Product Change Notification:

Reason for Product Change – Manufacture Process Change

Gas Sensing Solutions Ltd.   **PCN23-002, 18/09/2023**

CozIR-LP Series PCBA Information

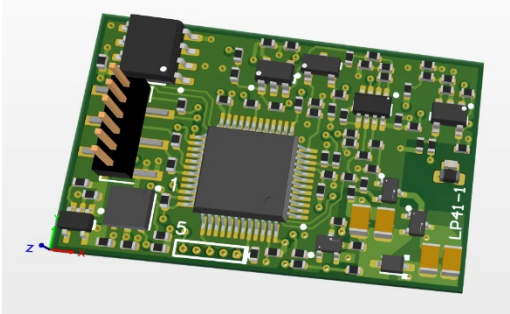
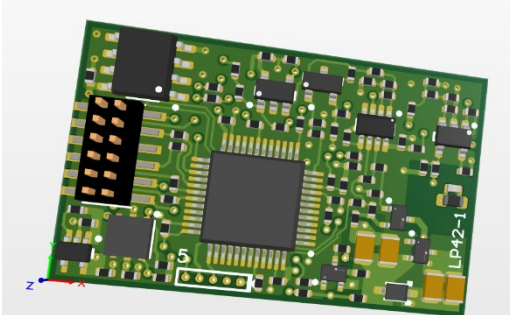
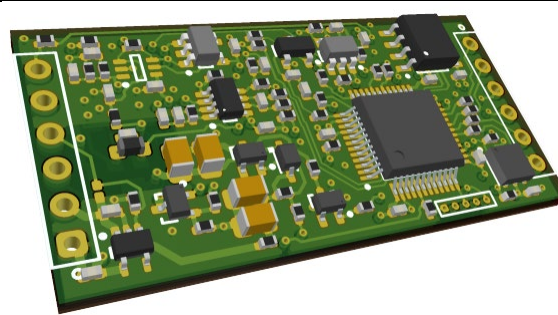
For logistical reasons GSS are changing the electronics design to ensure continuity of supply for the entire CozIR-LP series of sensors.

Electronic component supply has become difficult and consequently we have re-designed and harmonised the circuit for the entire LP series. This avoids potential obsolescence of parts in the near future.

1. The LP2-2 product has both Alarm and PWM functionality available, not enabled by default.
2. Pressure compensation is changed to provide direct input of ambient pressure avoiding the requirement for a look up table.
3. All products in the CozIR-LP series have the ability to specify, as an additional option, temperature, and humidity measurement. This is achieved by adding additional components, temperature and humidity can be read and output via the inbuilt firmware. Note The optional T+H sensor measures ambient temperature only – **not** in the temperature in the gas chamber. **T+H is available as a costed additional option from Q2 2024.**
4. Firmware code will change to a common format of **LPX-nnn** across the whole series, eg LPX-027. The only changes to the core command set are the additional ones stated above.

Updated CozIR LP1-2	Software Revision Information
	Y,Jun 28 2023,16:50:46,LPX-nnn Where; Jun 28 2023, 16:50 is the firmware compile date and time LPX-nnn is the firmware revision PCB A ID LP41-1

Updated CozIR LP2-2 / CozIR Blink-2	Software Revision Information
	Y,Jun 28 2023,16:50:46,LPX-nnn Where; Jun 28 2023, 16:50 is the firmware compile date and time LPX-nnn is the firmware revision PCB A ID LP42-1

Updated CozIR LP3-2 /CozIR Blink-N-2	Software Revision Information
	Y,Jun 28 2023,16:50:46,LPX-nnn Where; Jun 28 2023, 16:50 is the firmware compile date and time LPX-nnn is the firmware revision
